FACTORY SERVICE BULLETINS

“ESP Visit Workshop” Displayed In Instrument Cluster

All Model 203 Vehicles,
As of August 1, 2001
Series Production

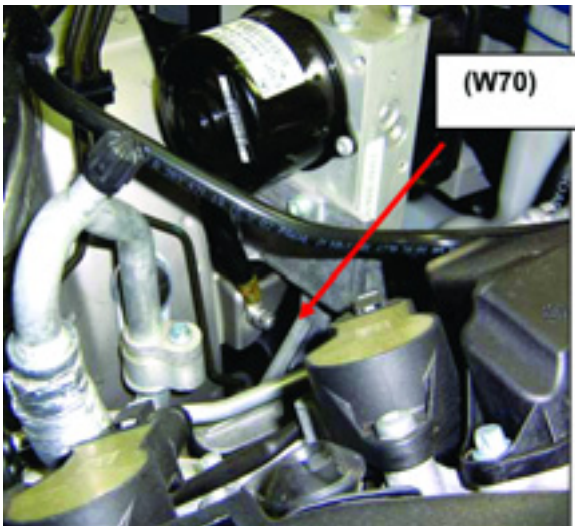
If “ESP – Visit Workshop” is being displayed in the instrument cluster, and for vehicles with an automatic transmission, the selector lever cannot be moved from position “P” after the engine is started, and various fault codes are stored in the relevant control units, perform the following repair.

The conditions listed above are caused by an inadequate ground connection at the ESP (W70) ground point (Figure 1, arrow) due to the heat shrinkable tube protruding under the ground cable lug’s attachment point.

- 1 Remove the excess length of the heat-shrinkable tube on the ground cable lug so that a complete ground connection can be established (Figure 2).

Note: Do not damage the coating on the ground cable lug. Additionally, ensure that the heat-shrinkable tube is only removed in the area of the screw attachment point.

2. Tighten the nut on the ground bolt (W70) to 8 Nm.
